**EPA Superfund
Record of Decision Amendment:**

**CENTRE COUNTY KEPONE
EPA ID: PAD000436261
OU 01
STATE COLLEGE BOROUGH, PA
03/08/2001**

**AMENDMENT NO. 1
TO THE RECORD OF DECISION
AT THE
CENTRE COUNTY KEPONE SUPERFUND SITE
OPERABLE UNIT #1**

**AMENDMENT NO. 1
TO THE RECORD OF DECISION**

Figure 1

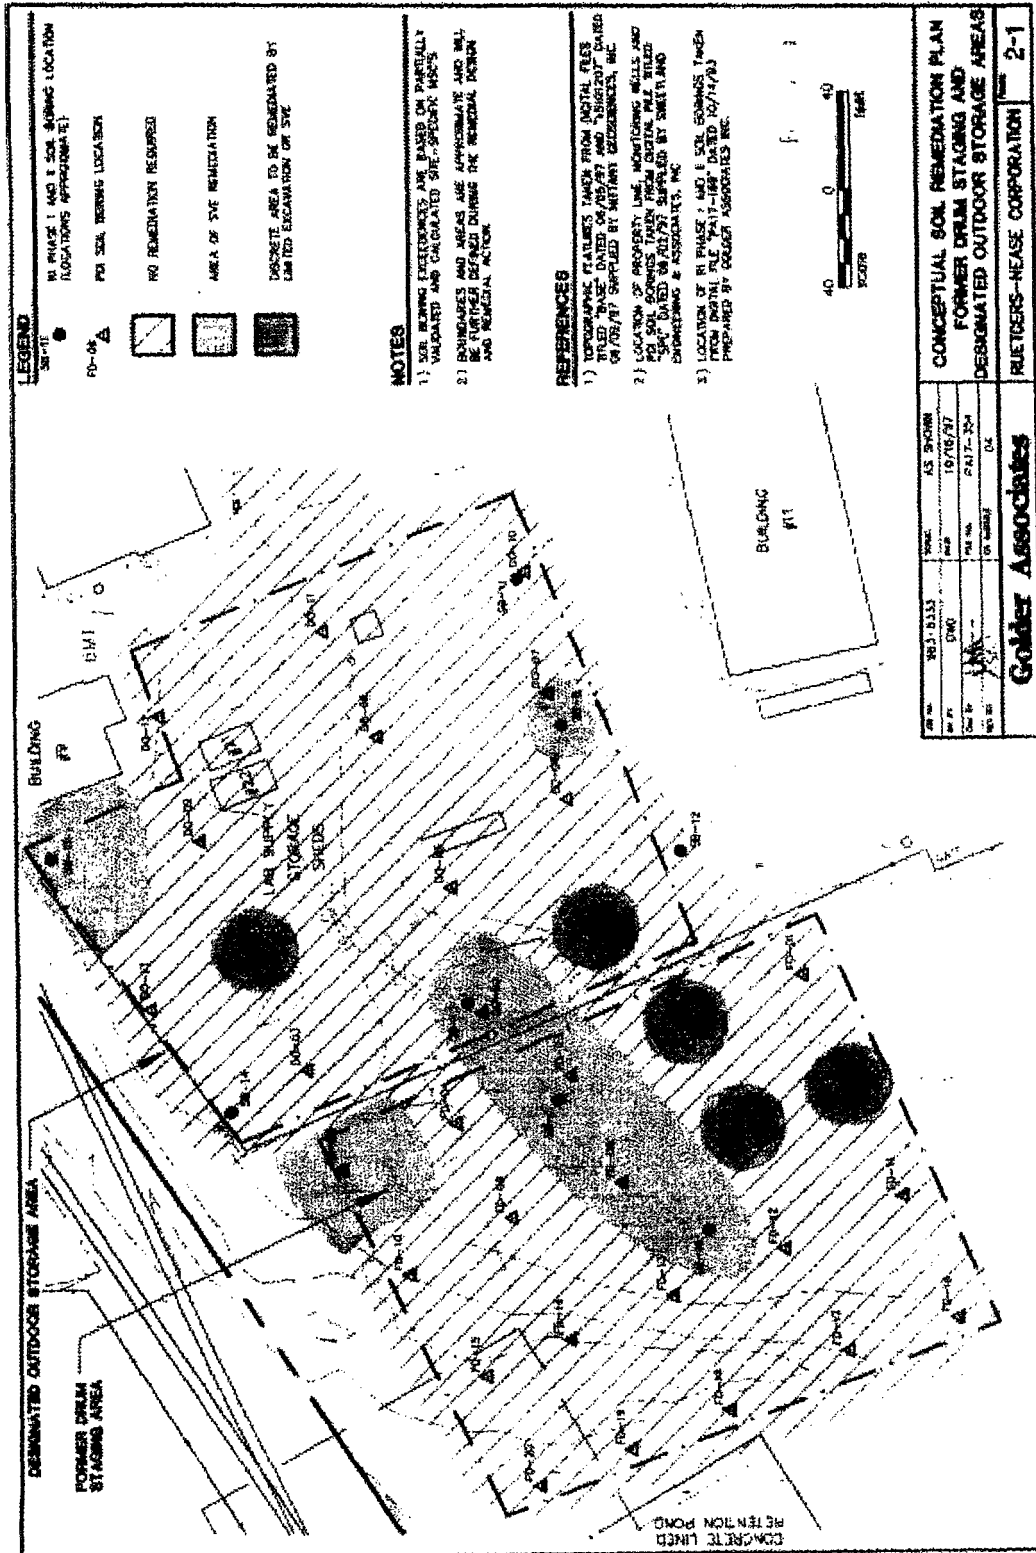
In areas where bedrock is near the ground surface (less than 6 feet), excavation will be performed to remove VOCs instead of SVE. Excavation will still occur in all areas where mirex and kepone exceed the clean-up criteria. Excavated soils will be disposed of off-site possibly following thermal treatment, if required. Excavated soils that are determined to be hazardous (either by characteristic or by virtue of containing listed hazardous materials at elevated concentrations) will be disposed in accordance with current regulations, including the Phase IV LDR rule (63 FR 2855; May 26, 1998). This regulation allows for hazardous contaminated soil containing constituents at greater than 10 times the Universal Treatment Standard (“UTS”) to be treated to achieve 90% reduction of constituents, or treated down to a concentration 10 times the UTS, whichever is greater, prior to land disposal. Based on the data generated during the Pre-Design Investigation, approximately 120 cubic yards of material may be excavated.

- In-situ treatment by SVE to remove VOCs from the Former Drum Staging Area; the Designated Outdoor Storage Area; and the Tank Farm/Building #1 Area, including VOCs in overburden, unsaturated bedrock and in proximity to buildings and process areas;
